# KFL1-4 KIT CHANGES AND MANUAL ERRATA

Rev. A-4, January 17, 2011

Figure 1

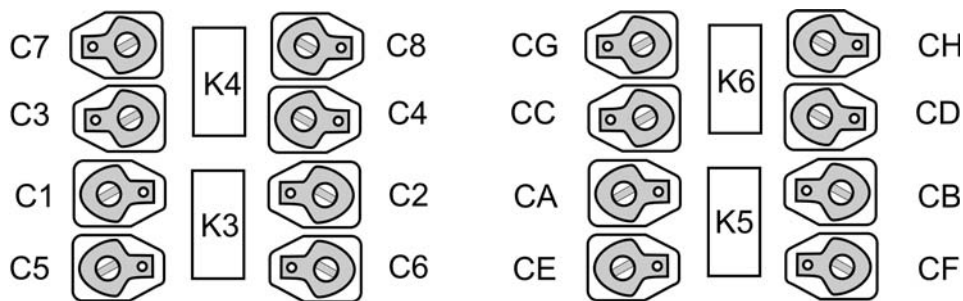
The approximate locations of the 16 trimmer capacitors on the Filter board are shown in Figure 1. Relays K3-K6 are shown for reference. **Note that each trimmer's body has a narrow end, and that they are not all oriented in the same direction.** The trimmers must be oriented as shown to keep their rotor terminals at ground potential. This will allow them to be aligned with a metallic tool.

Install trimmer capacitors C1-C8 and CA-CH with their narrow ends oriented as indicated above (toward the flat side of the outline on the pc board). Each trimmer must be gently pressed down as far as it will go, but be careful not to bend the leads.
